V2500-A1/A5/D5 SERIES PROPULSION SYSTEMS SERVICE BULLETIN

This document transmits Revision 1 to Service Bulletin EV2500-72-0434

V2500-ENG-72-0434
Transmittal - Page 1 of 2

ENGINE – PROVIDE NEW NUMBER 4 BEARING INNER WEEP TUBE AND OUTER WEEP MANIFOLD

FAMILY TREE – TUBE ASSEMBLY NO.4 BEARING COMPARTMENT

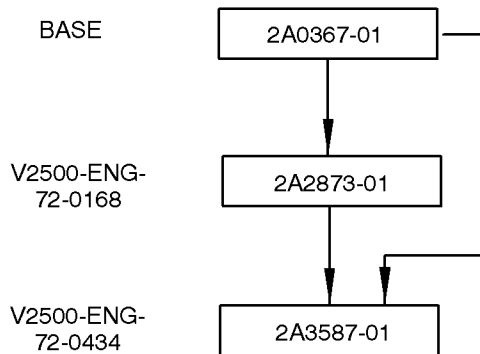
New PN	Qty	Estimate of Unit Price (\$)	Keyword	Old PN (ATA/Figure/Item)	Inst - Disp
2A3587-01	1		.Tube Assy of, Weep, No. 4 Brg. Outer	2A2873-01 (72-42-20-03-040)	(2)(B) (N)(I)

New PN	Qty	Estimate of Unit Price (\$)	Keyword	Old PN (ATA/Figure/Item)	Inst - Disp
2A3587-01	1		.Tube Assy of, Weep, No. 4 Brg. Outer	2A0367-01 (72-42-20-03-040)	(2)(B) (N)(I)

REPLACE TUBE ASSEMBLY
2A2873-01 OR 2A0367
WITH 2A3587-01
